**RE: Minor change application
Proposed subdivision
2 Hellen Street, Bald Hills
Council reference: A006240008**

We are writing in relation to the abovementioned development approval, to request a change to the approval pursuant to section 78 of the *Planning Act 2016* (the Act), in accordance with provisions of section 81 (minor change).

Figure 1: Civil Engineering Plan - area of proposed fill (Source: Civil works engineers).

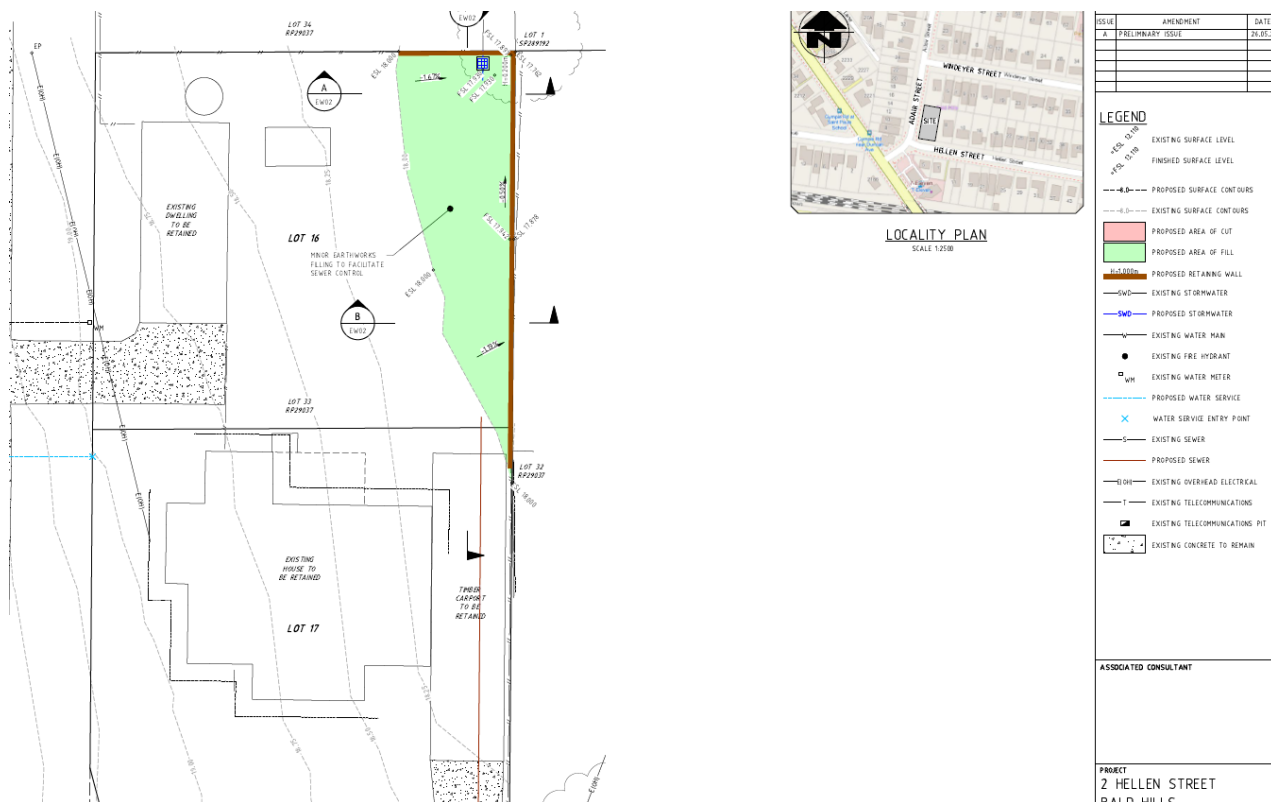
The approved plan provides fill to facilitate stormwater drainage. The proposed change will reduce the total earthworks to a proposed 4.2m³ to facilitate sewer control instead of stormwater drainage. Still ensuring no proposed retaining walls exceed 1 m in height, refer to figure 1 below.
